CCK-2568-22

ADDENDUM # 4

CONSTRUCT/ IMPROVE GREEK HOUSING (DELTA GAMMA) Bid Package #2 – All Work Categories

UNIVERSITY OF KENTUCKY
 2555.0 Construct/Improve Greek Housing
 (Delta Gamma House)

© BROWN + KUBICAN, PSC

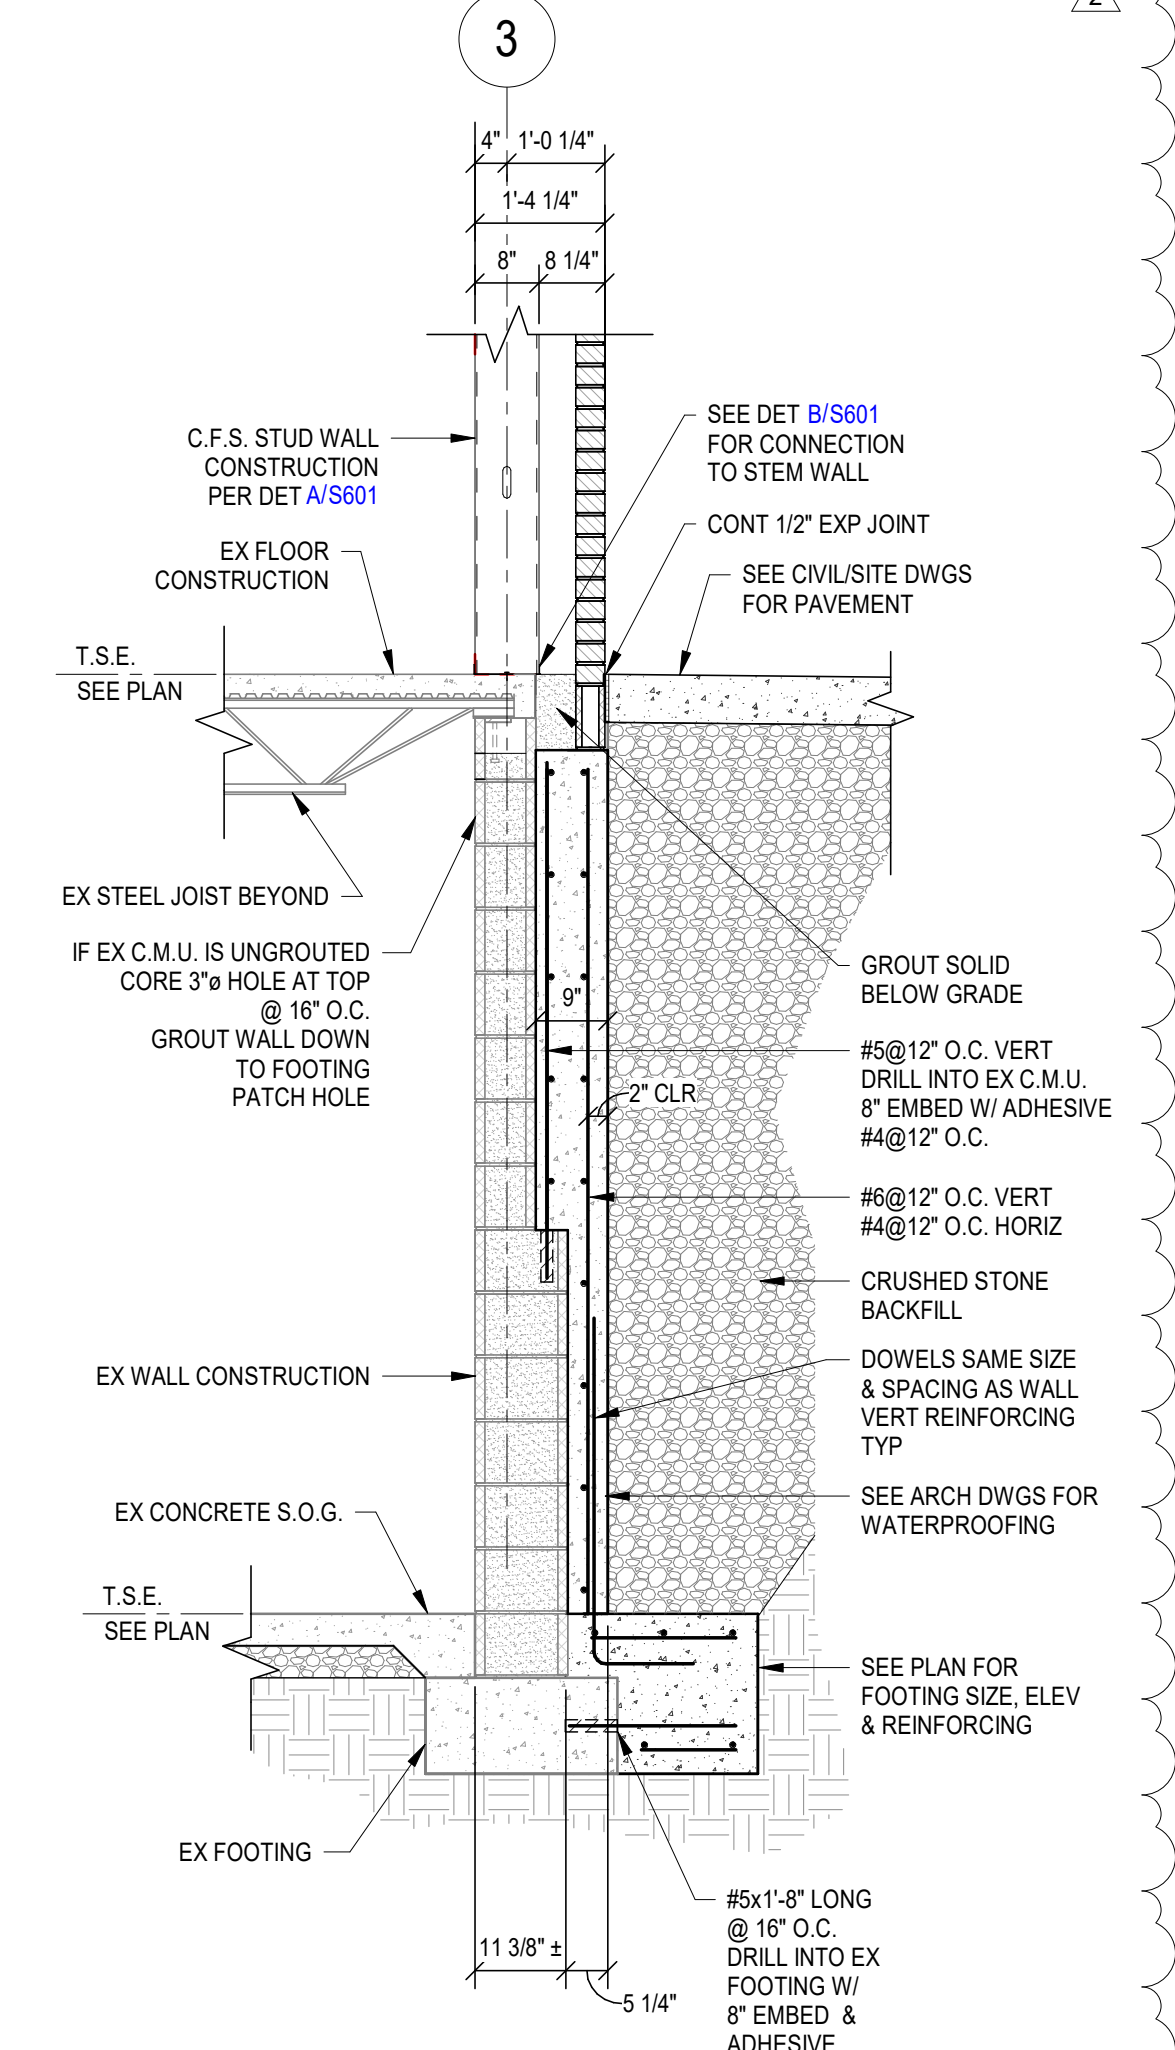
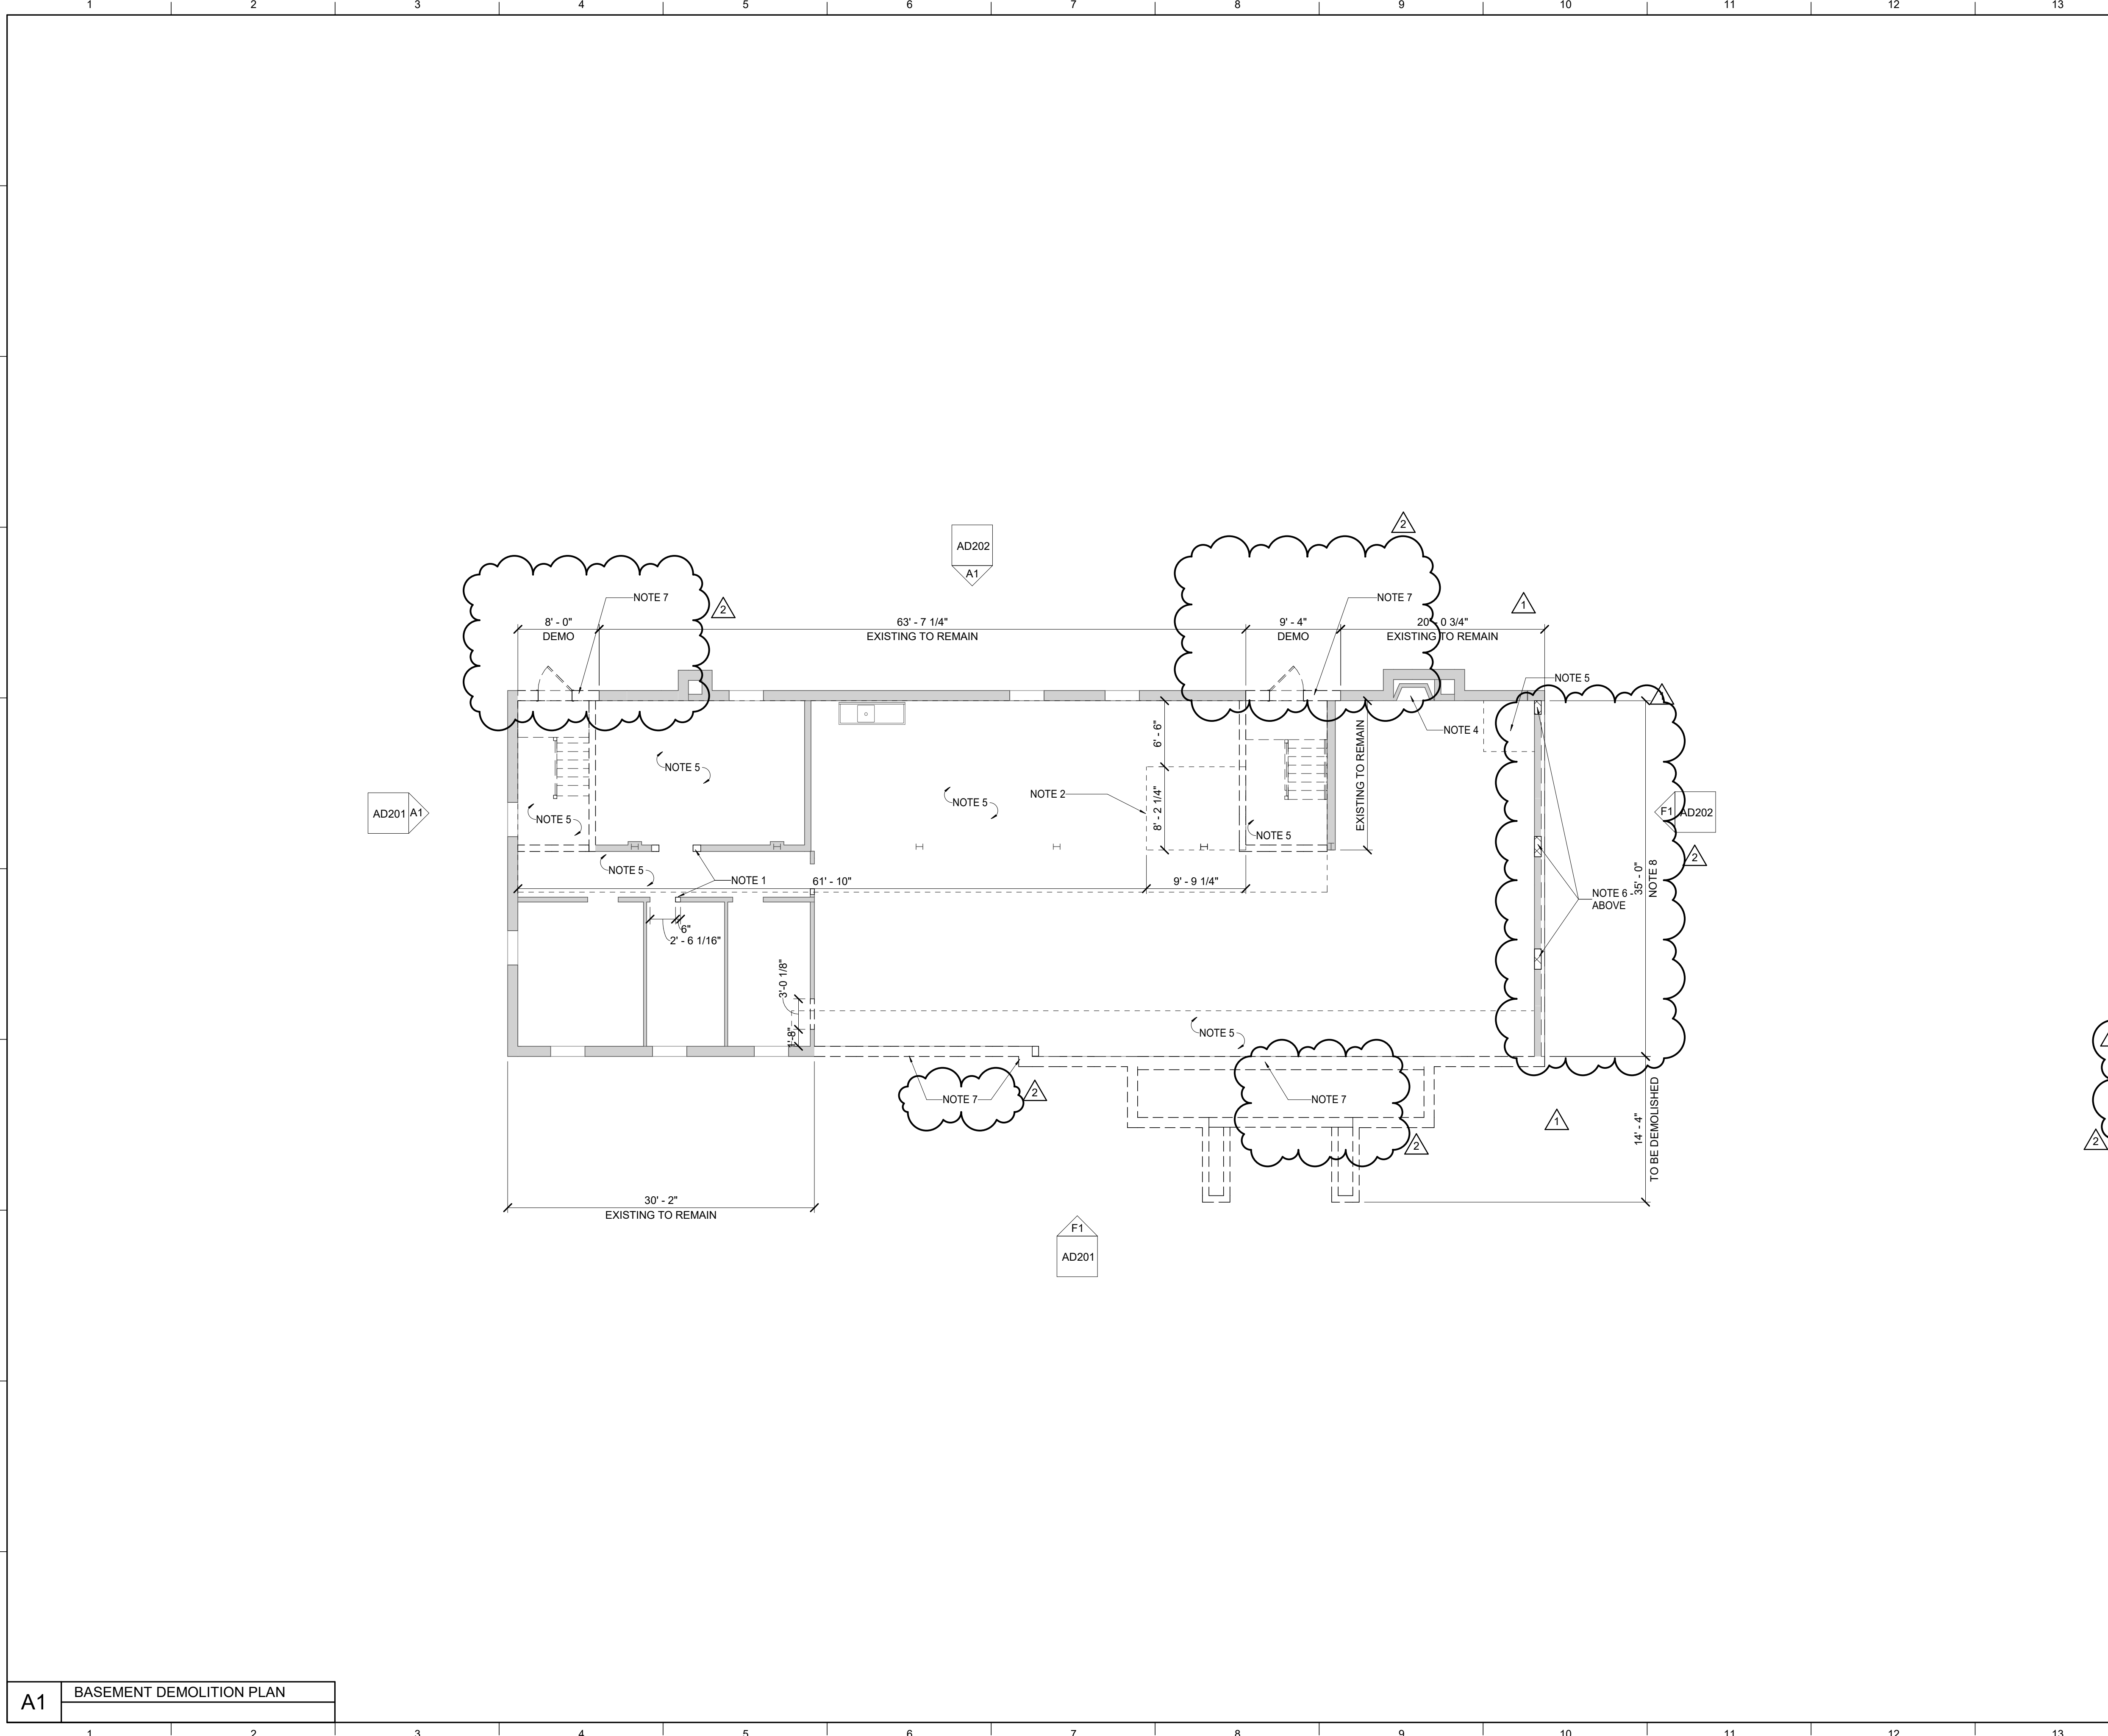
<ul style="list-style-type: none"> • Changed Tag Note 31 to "NEW JOIST BEARING PER DET L/S402 OR DET J/S404." 	
S305	FOUNDATION SECTIONS	9/7/21
	<ul style="list-style-type: none"> • Section C/S305 – Edit foundation dowel note. • Added Section D/S305. 	
S402	TYPICAL FRAMING DETAILS	9/7/21
	<ul style="list-style-type: none"> • Added Detail L/S402

A1 BASEMENT DEMOLITION PLAN

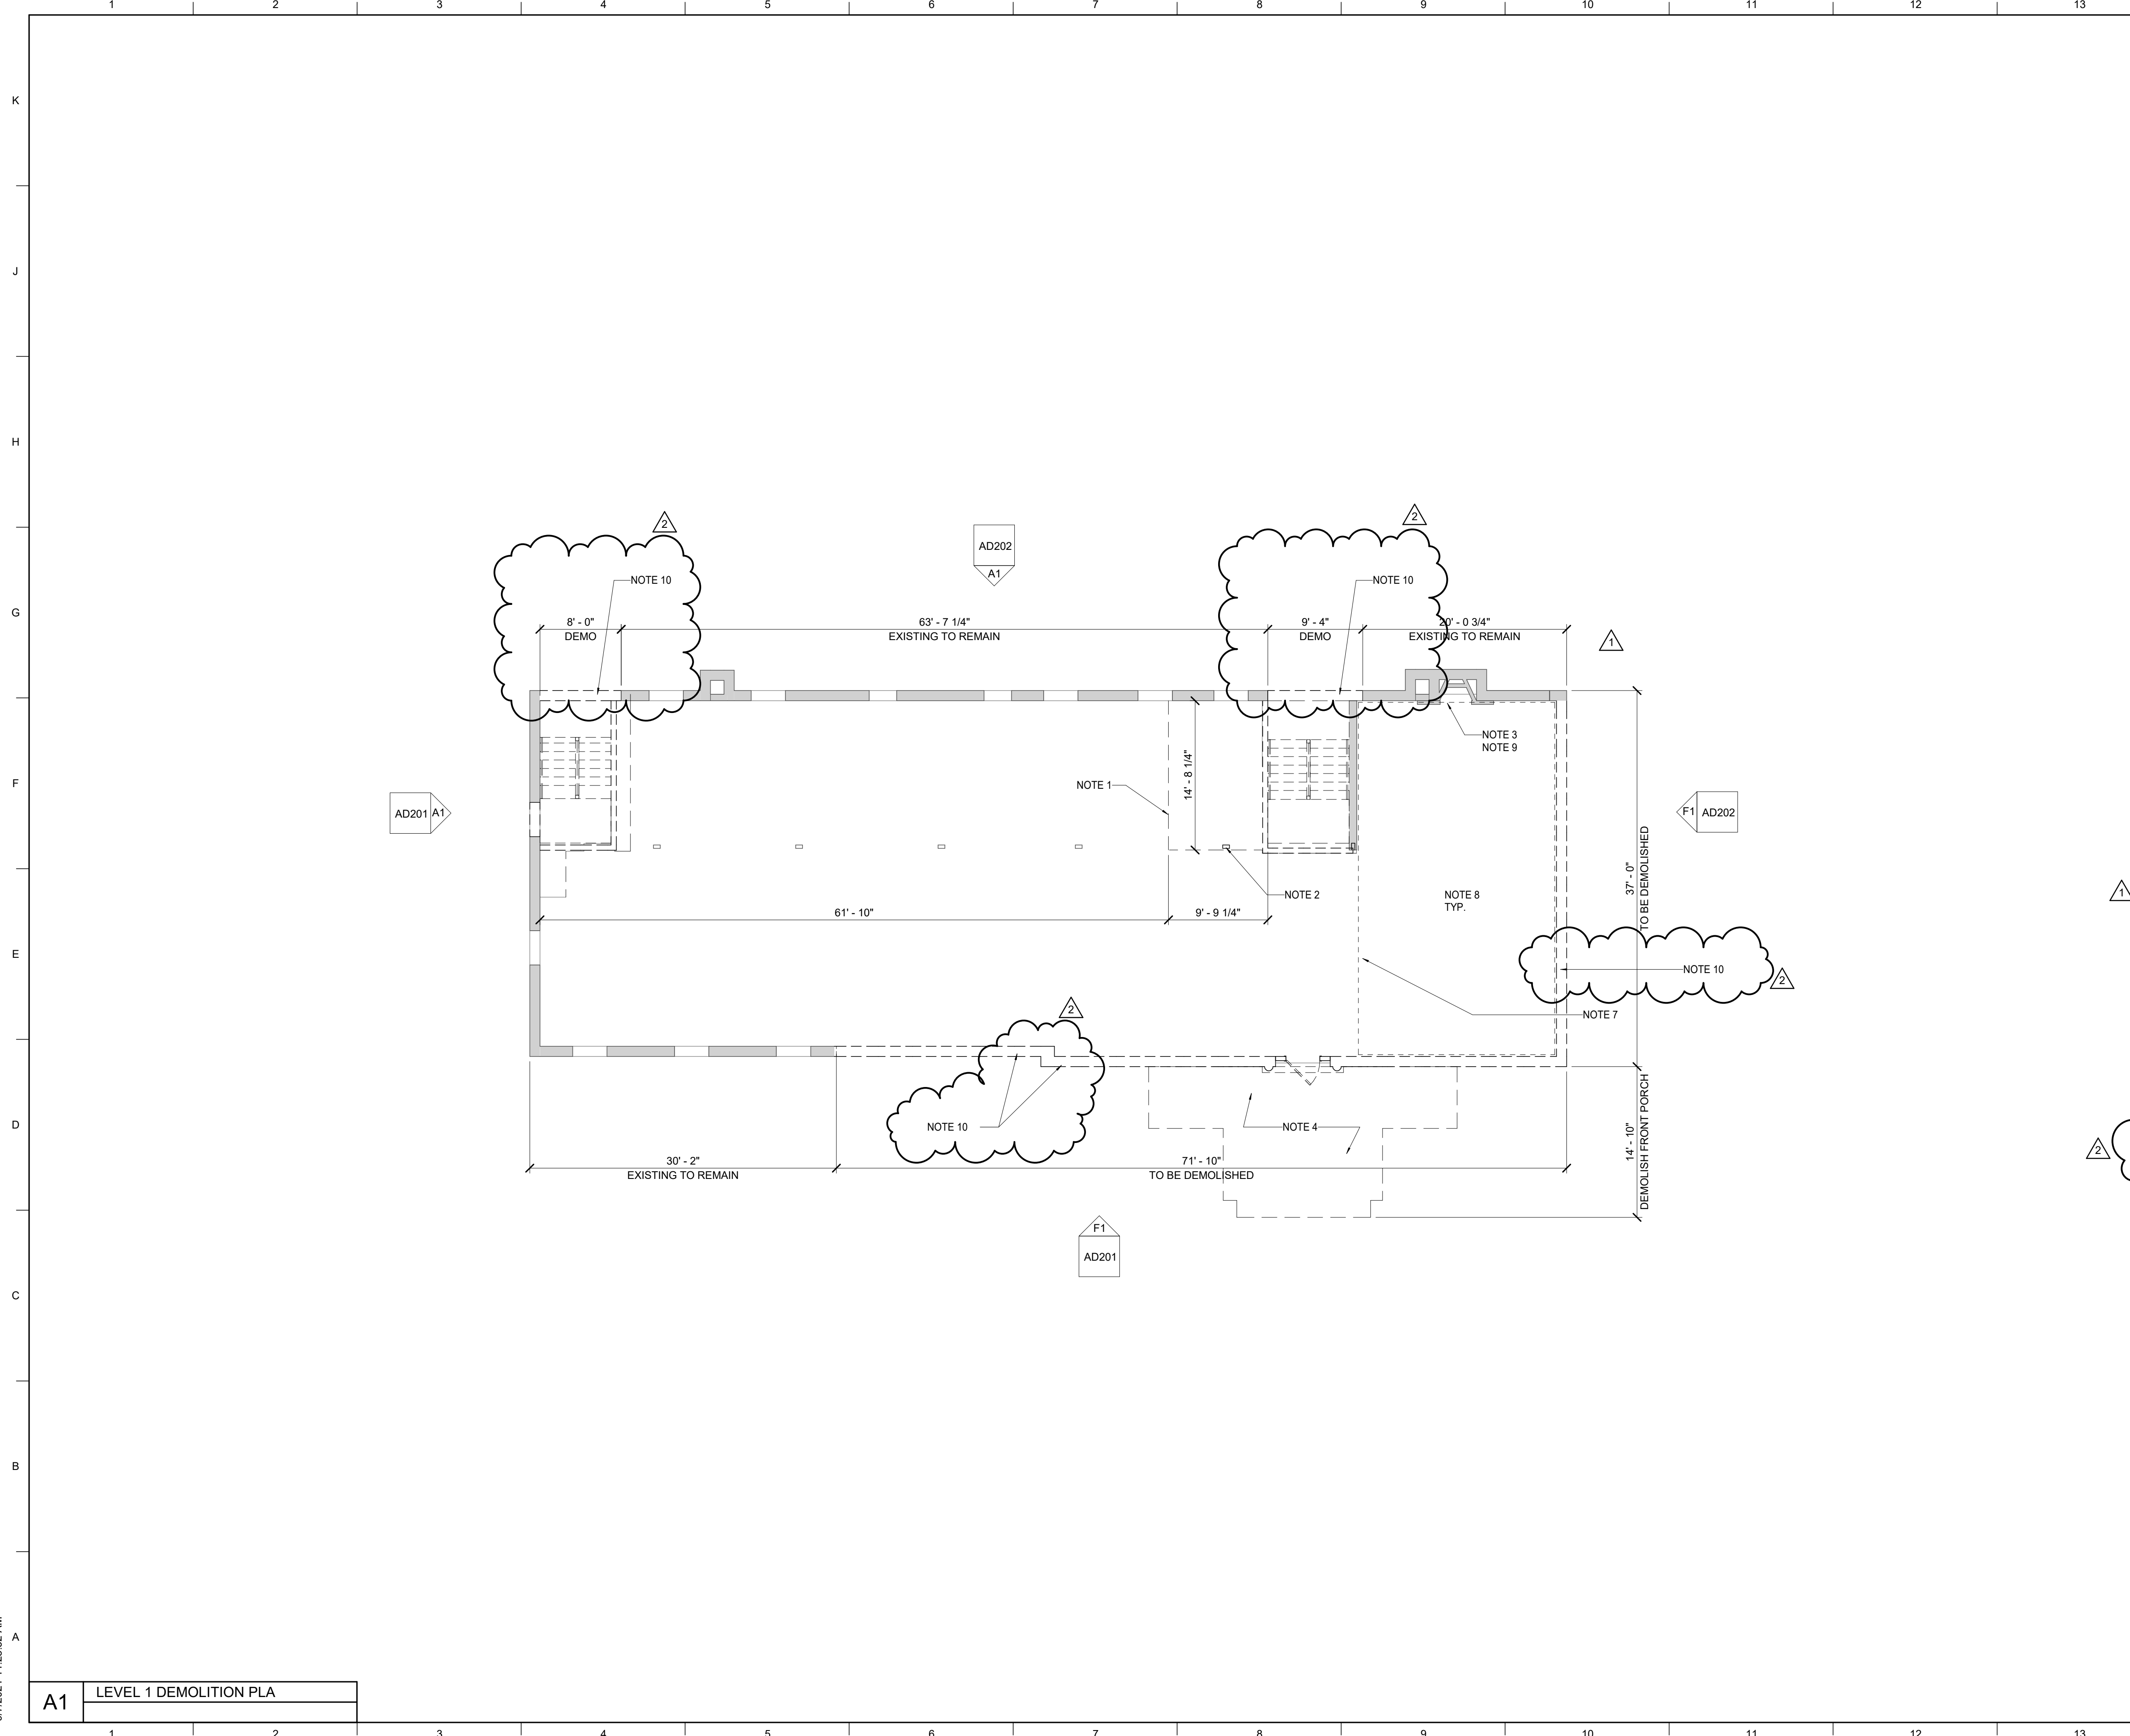
AD100	<p>DEMOLITION PLAN - BASEMENT</p> <ul style="list-style-type: none"> • Added Sheet Specific Note 7: Wall being removed under separate contract. Wall removal show for reference only. All required shoring and related items still to be included in this scope of work. • Added Sheet Specific Note 8: Brick face being removed under separate contract. Wall removal shown for reference only. All required shoring and related items still to be included in this scope of work. • Tagged note 7 on both stair walls and the Plan South basement wall. • Tagged note 8 on Plan East existing basement wall. 	9/7/21
AD101	<p>DEMOLITION PLAN – LEVEL 0</p> <ul style="list-style-type: none"> • Added Sheet Specific Note 10: Wall being removed under separate contract. Wall removal show for reference only. All required shoring and related items still to be included in this scope of work. • Tagged note 10 on both stair walls, plan east and Plan South wall. 	9/7/21
